WB6DHW 9912 board interface

WA6UFQ

Rev 1.0

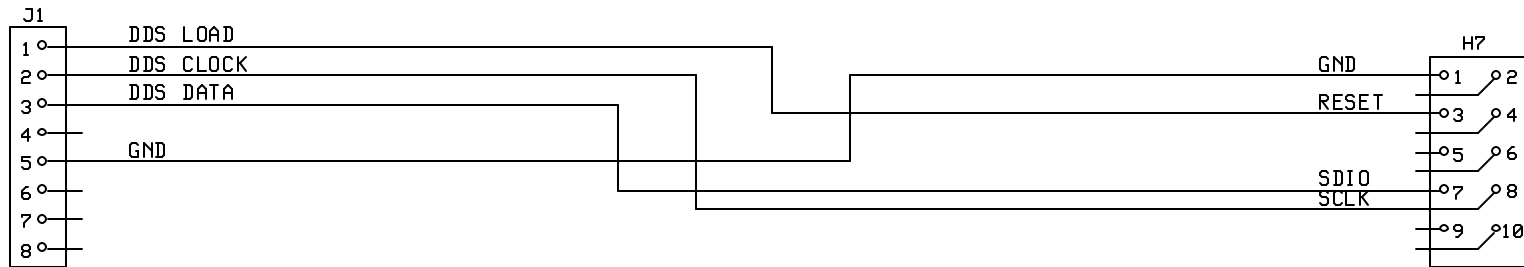
1. Remove 10K resistor R21
2. Install 10K resistor R22
3. Cut the three traces going to H7 pins 3,7 & 8 from PIC
4. Remove shunt on header H2
